PUBLIC HEARING MEMORANDUM

SUBJECT: Petition #378-21, for SPECIAL PERMIT/SITE PLAN APPROVAL to extend the

9-11 Circuit Avenue

ZONING REVIEW MEMORANDUM

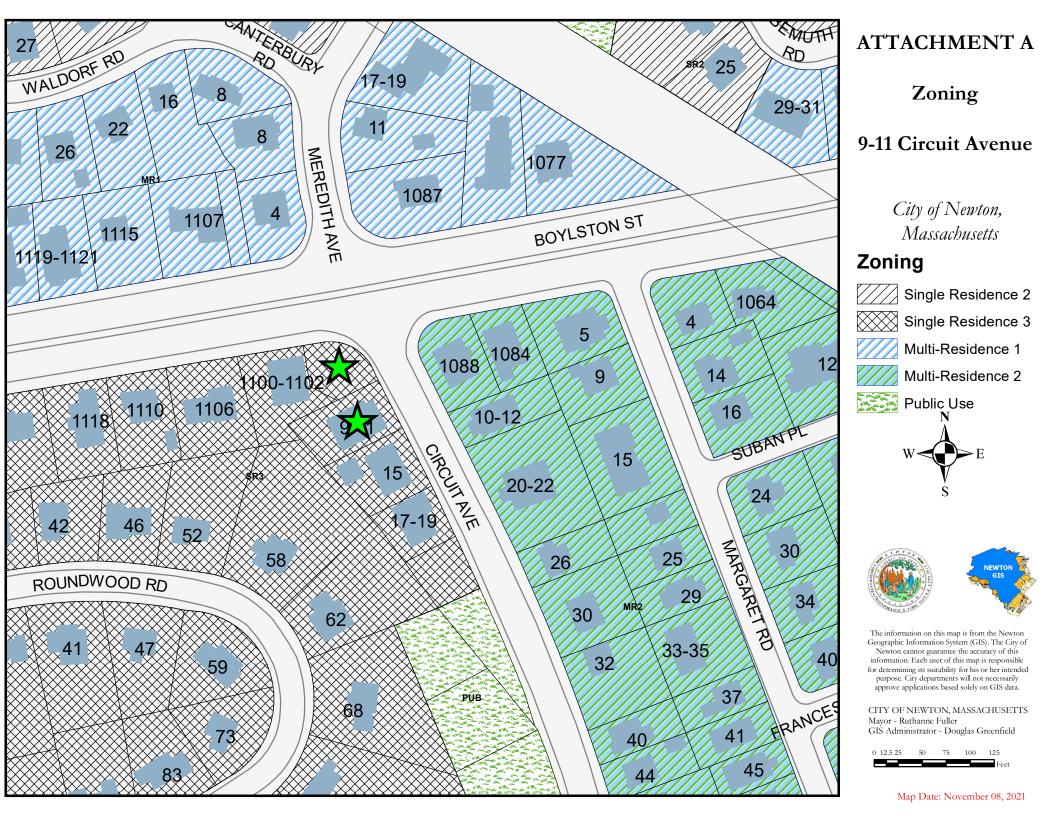
The curb cut is 13.2 feet wide, and the proposed drive aisle is 23 feet wide, it further narrows to 9.9 feet between the landing of the structure and northwest property line. Two-way drive aisles require an aisle of 24 feet in width. The placement of the parking facility also places four stalls within the required setback distances from Circuit Avenue and Boylston Street.

The Planning Department notes that relocating the parking further into the site would eliminate the relief for parking within the front setback and within five feet of the

street. This would also allow additional landscaping at the front of the site to screen the parking area. The petitioner should also clarify if garage stalls 5 and 6 would utilize the paved area within the 45-degree angle on the neighbor's property to exit the site.

The Planning Department suggests the petitioner consider screening where possible around the parking facility, but also as to not interfere with a clear sight distance from Boylston Street.
